**PCN#20191212001.1
New Tray for Select Devices
Final Change Notification**

Date: January 29, 2020

PCN Number:		20191212001.1		PCN Date:		Jan 29 2020	
Title:	New Tray for Select Devices						
Customer Contact:		PCN Manager		Dept:	Quality Services		
Proposed 1st Ship Date:		Apr 28, 2020		Sample Eval Period:	90 days		
Last Time Buy Date:		June 28, 2020		Last Time Ship Date:	Sept 28, 2020		
Change Type:							
<input type="checkbox"/>	Assembly Site	<input type="checkbox"/>	Assembly Process		<input type="checkbox"/>	Assembly Materials	
<input type="checkbox"/>	Design	<input type="checkbox"/>	Electrical Specification		<input type="checkbox"/>	Mechanical Specification	
<input type="checkbox"/>	Test Site	<input checked="" type="checkbox"/>	Packing/Shipping/Labeling		<input type="checkbox"/>	Test Process	
<input type="checkbox"/>	Wafer Bump Site	<input type="checkbox"/>	Wafer Bump Material		<input type="checkbox"/>	Wafer Bump Process	
<input type="checkbox"/>	Wafer Fab Site	<input type="checkbox"/>	Wafer Fab Materials		<input type="checkbox"/>	Wafer Fab Process

Group 1 Change Description - 14 x 14 TQFP Tray Change:

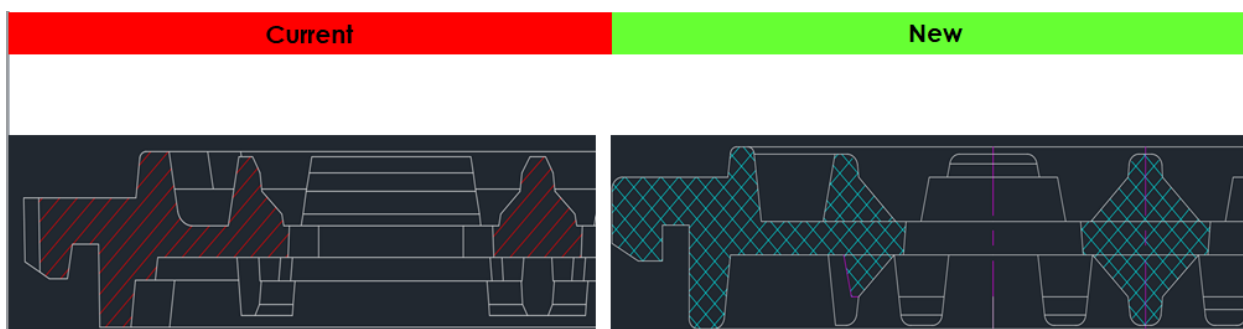
4223432-0001	4224972-0001
Supplier	UBOT	Peak
Floor design	Circular square	Octagon
Cavity size	16.55 +/- 0.08	16.10 +/- 0.08
Seating height	1.52 mm (top) 0.75 mm (bottom)	1.5 mm(top) 0.9 mm (bottom)

EXISTING	PROPOSED	COMMENT
	4223432-0001	4224972-0001	CHANGE
* Supplier Part Number :	UQ1414 1.0 0615XB	ND 1414 1.0 0615 13 REV.G	CHANGE
* Gram Weight:	155	157	CHANGE
* Surface Resistivity :	10 ⁴ - 10 ¹⁰ ohm/sq	10 ⁴ - 10 ¹⁰ ohm/sq	UNCHANGE
* Package Size :	14x14x1.0	14x14x1.0	UNCHANGE
* Package Type :	TQFP	TQFP	UNCHANGE
Temperature Rating :	150C	150C	UNCHANGE
Matrix (Column X Rows) :	06x15	06x15	UNCHANGE
Fence design	Fillet	Fillet	UNCHANGE
Raw Material :	Carbon Fiber	Carbon Fiber	UNCHANGE
Color :	BLACK	BLACK	UNCHANGE
FLOOR DESIGN			CHANGE

Group 3 Change Description - 13 x 13 BGA Tray Change:

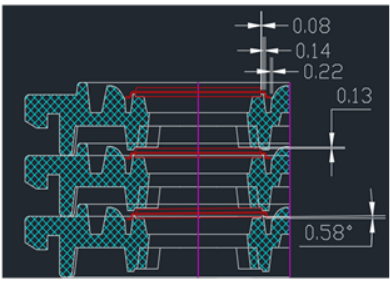
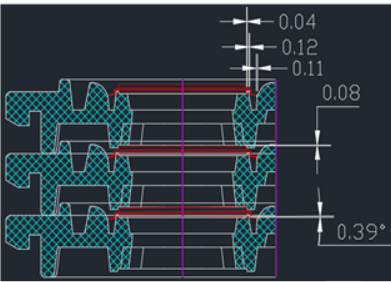
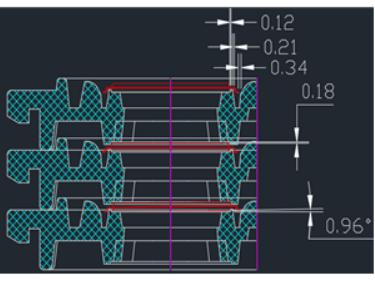
4212436-0001	4224857-0001
Supplier	UBOT	Peak
Tray Fence	Chamfered	Fillet
Cavity size (LSL)	13.30 + 0.08 13.30 - 0.04	13.30 + 0.08 13.30 - 0.08
Seating ht	1.64 mm (top) 2.00 mm (bottom)	1.27 mm(top) 1.37 mm (bottom)

MATERIAL DESCRIPTION	EXISTING	PROPOSED	COMMENT
	4212436-0001	4224857-0001	CHANGE
* Supplier Name :	UBOT	Peak	CHANGE
* Supplier Part Number :	UB13131.40820XB	NX BG1313 1.74 0820 13	CHANGE
* Gram Weight:	110	132.5	CHANGE
* Surface Resistivity :	1 exp5 - 1 exp11	1 exp5 - 1 exp11	NO CHANGE
* Package Size :	13x13	13x13	NO CHANGE
* Package Type :	BGA	BGA	NO CHANGE
Temperature Rating :	150C	150C	NO CHANGE
Matrix (Column X Rows) :	8x20	8x20	NO CHANGE
Raw Material :	Carbon fiber	Carbon fiber	NO CHANGE
Thickness :	7.62 mm	7.62	NO CHANGE
Color :	BLACK	BLACK	NO CHANGE
Floor Design	Yes	Yes	NO CHANGE

ITEM DESCRIPTION	4212436-0001 UB13131.40820XB			4224857-0001 NX BG1313 1.74 0820 13			COMMENT
	DIM	Upper Limits	Lower Limits	DIM	Upper Limits	Lower Limits	
Overall Length	322.6	322.85	322.35	322.6	322.85	322.35	NO CHANGE
Layout Length	315.0	315.25	314.75	315.0	315.25	314.75	NO CHANGE
Layout Width	135.9	136.15	135.65	135.9	136.15	135.65	NO CHANGE
Layout Length on Top Stack frame	311.15	311.40	311.02	311.15	311.40	311.02	NO CHANGE
Layout Width on Top Stack frame	132.08	132.33	131.95	132.08	132.33	131.95	NO CHANGE
Layout Length on Bottom Stack frame	311.66	311.91	311.53	311.66	311.91	311.53	NO CHANGE
Layout Width on Bottom Stack frame	132.59	132.84	132.46	132.59	132.84	132.46	NO CHANGE
End Tab Length	92.1	92.35	91.85	92.1	92.35	91.85	NO CHANGE
Overall Height	7.62	7.75	7.49	7.62	7.75	7.49	NO CHANGE
Stack Height	1.27	1.40	1.14	1.27	1.40	1.14	NO CHANGE
Tray Matrix No.	08x20			08x20			NO CHANGE
Pitch M	15.45	15.58	15.32	15.45	15.58	15.32	NO CHANGE

Pitch M3	15.00	15.13	14.87	15.00	15.13	14.87	NO CHANGE
Pitch M1	15.00	15.13	14.87	15.00	15.13	14.87	NO CHANGE
Pitch M2	15.00	15.13	14.87	15.00	15.13	14.87	NO CHANGE
Distance of tray singulation from corner of tray	34.30	34.55	34.05	34.30	34.55	34.05	NO CHANGE
Tray singulation width	25.40	25.53	25.27	25.40	25.53	25.27	NO CHANGE
Tray Lifting surface height	2.54	2.67	2.41	2.54	2.67	2.41	NO CHANGE
Cavity Size (X)	13.30	13.38	13.26	13.30	13.38	13.22	CHANGE
Cavity Size (Y)	13.30	13.38	13.26	13.30	13.38	13.22	CHANGE
Pedestal Design	SLOPE			SLOPE			NO CHANGE
Package seating height (Top)	1.64	1.71	1.57	1.27	1.37	1.17	CHANGE
Package seating height (Bottom)	2.00	2.05	1.92	1.35	1.45	1.25	CHANGE
